GMA-12 DFCs

Summary of Environmental Stewardship's Comments and Requests

**Presented to
GMA-12
December 10, 2020, Virtual Meeting**

Figure 8. Colorado River at Bastrop gage during drought period Jan. 2011 - Dec. 2013. A hydrograph separation is requested for the period.

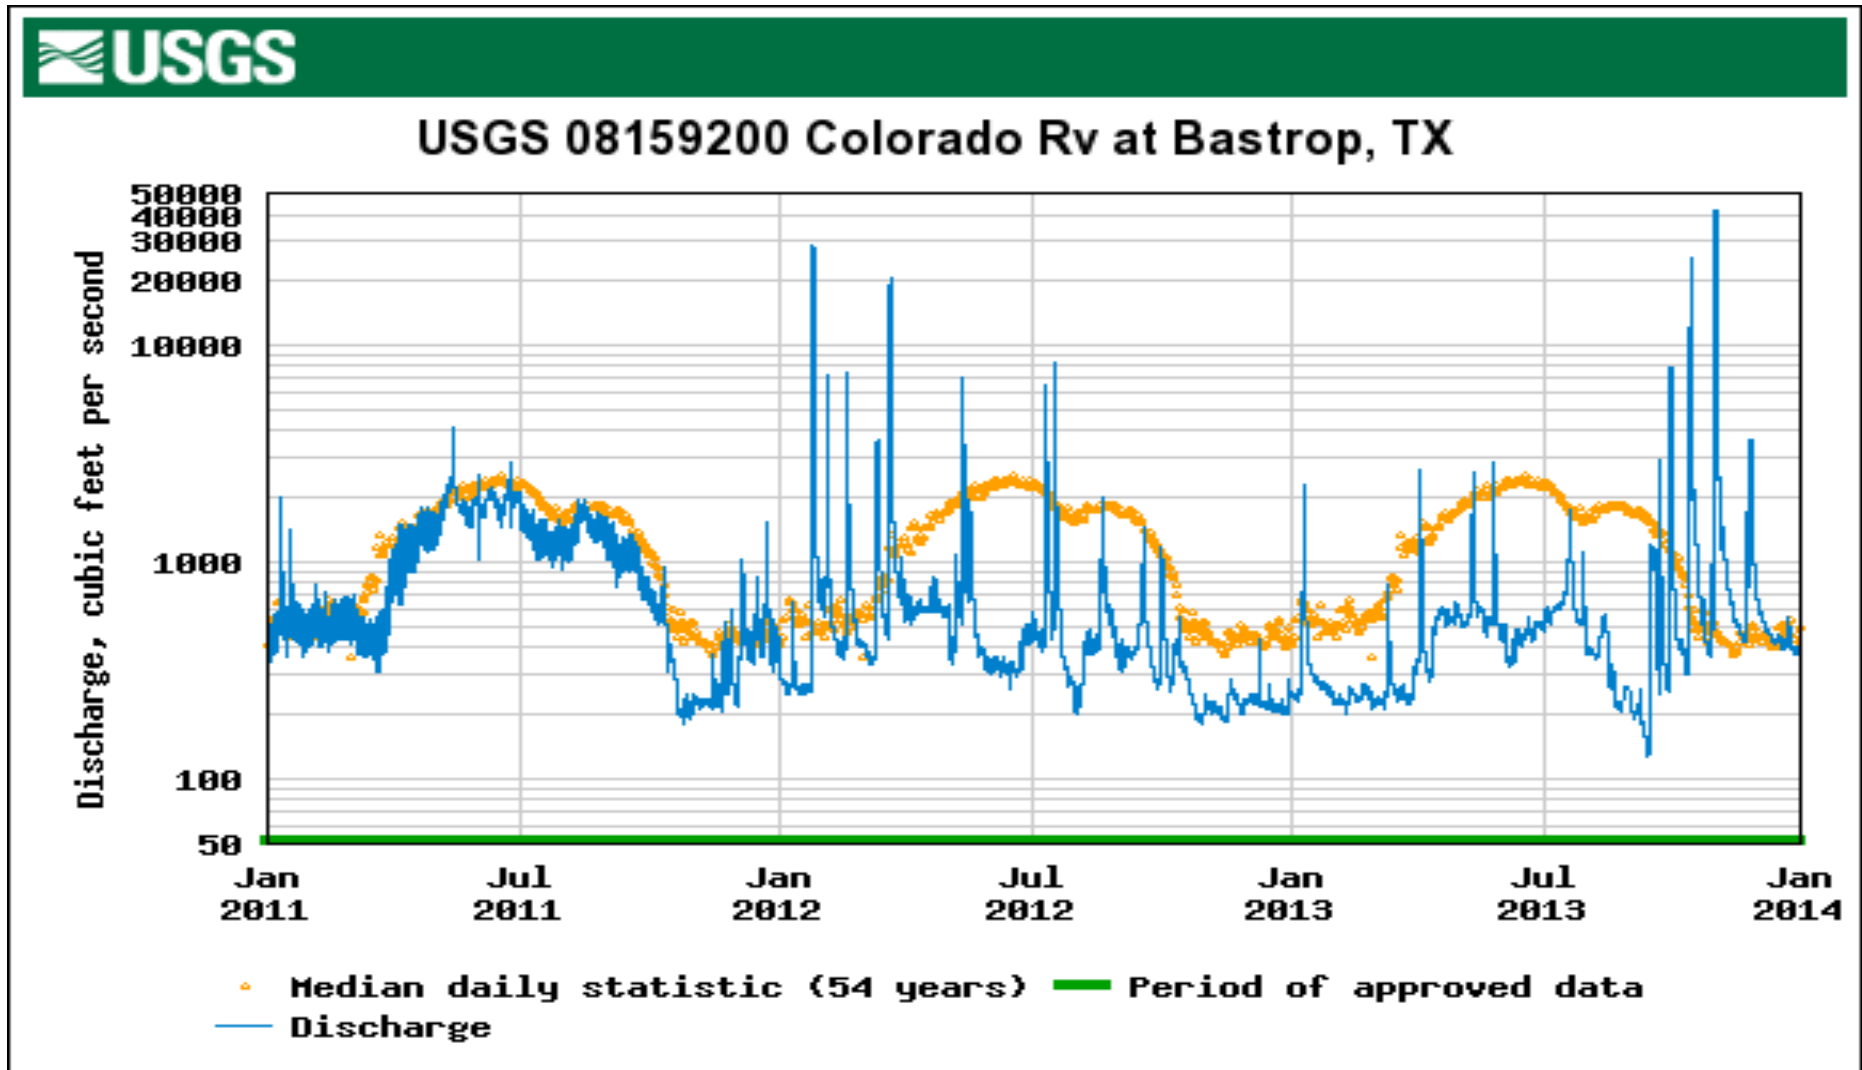
- A hydrograph separation on the three-year period represented in Figure 8, with irrigation releases and return-flows accounted for, would likely reveal a very good estimate of actual groundwater outflows to the river from the Carrizo-Wilcox Aquifer group.
- During this period the bank storage for the river had likely been exhausted and the river was relying on the minimum flows passing through the Austin gage at Longhorn Dam, City of Austin, Pflugerville and Elgin return flows, and groundwater baseflows.

- Environmental Stewardship again requests that GMA-12 direct the consultants to prepare hydrographic separations as described above for the period January 2011 through December 2013 for the Bastrop, Wilbarger and Big Sandy gages of the Colorado River to gain insights on the quantity of groundwater that was being contributed to river flow for this extraordinary drought period.
